VALENCIA CORNER SUBDIVISION

Engineering Comments: FINAL PLAT COMMENTS (should be addressed prior to submitting the FINAL PLAT for acceptance and signature by the City Engineer):

APPLICATION NUMBER 4 DATE November 17, 2016

DETAIL SITE PLAN

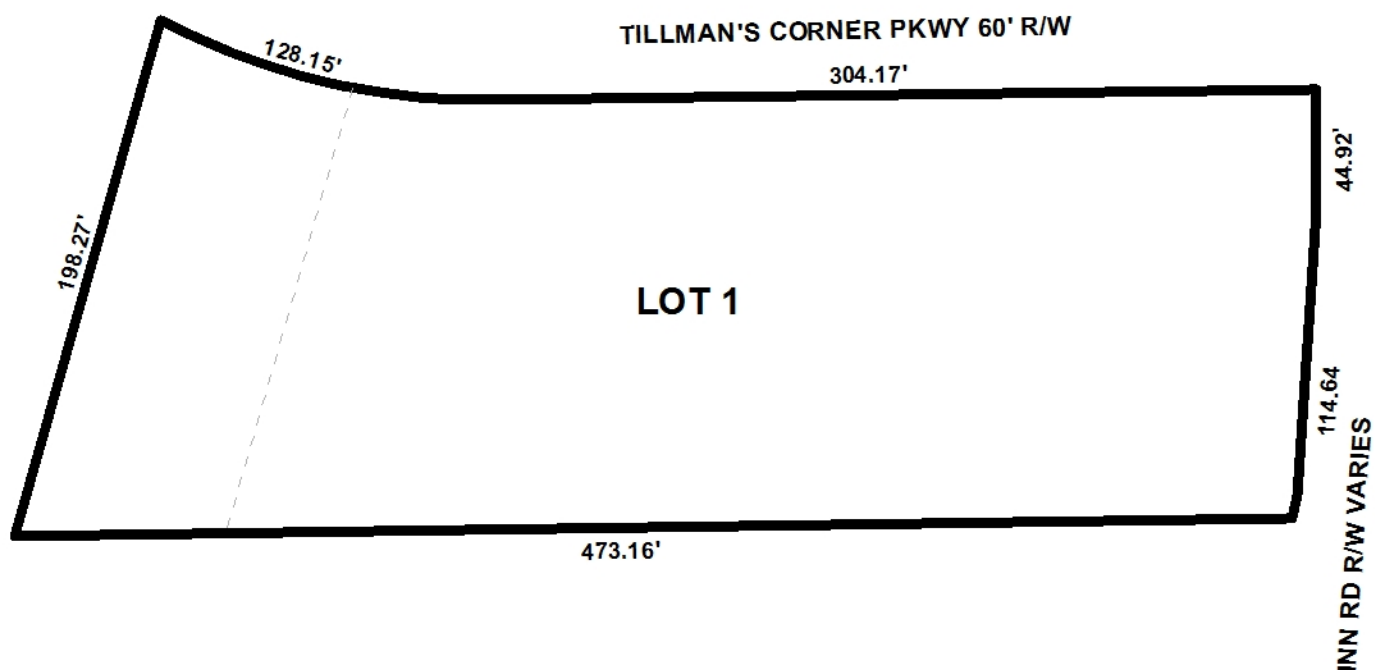
The subject lot fronts both Inn Road and Tillmans Corner Parkway. Inn Road and Tillmans Corner Parkway are minor streets without curb and gutter. Minor streets without curb and gutter require a 60' wide right-of-way width; however, Inn Road is an ALDOT maintained roadway and access to Inn Road is subject to ALDOT approval. The right-of-way width for Inn Road is depicted as "varies" and should be revised to indicate a minimum width of 60' on the Final Plat, if approved. The right-of-way width for Tillmans Corner Parkway is depicted as 60' on the preliminary plat and should be retained as such on the Final Plat, if approved.

The 25-foot minimum building setback line is not depicted on the preliminary plat along either Tillmans Corner Parkway or Inn Road. If approved, the Final Plat must be revised to illustrate the 25-foot minimum building setback lines on the subject site.

The proposed lot exceeds the 7,200 square foot minimum lot size requirements for lots served by public water and sanitary sewer systems. The lot size information is indicated in both square feet and in acres and should be retained on the Final Plat, if approved.

As a means of access management, a note should be placed on the Final Plat stating that the lot is limited to two curb cuts to Tillmans Corner Parkway, with any changes to the size, location and design to be approved by Traffic Engineering and conform to AASHTO standards.

- 1) Retention of the right-of-way width along Tillmans Corner Parkway;
- 2) Revision of the right-of-way width along Inn Road to depict a width of 60';

- 3) Revision of the Final Plat to illustrate the 25-foot minimum building setback lines along both Inn Road and Tillmans Corner Parkway;
- 4) Retention of the lot size information in both square feet and in acres;

- 5) Placement of a note on the Final Plat stating that the lot is limited to two curb cuts to Tillmans Corner Parkway, with any changes to the size, location and design to be approved by Traffic Engineering and conform to AASHTO standards;
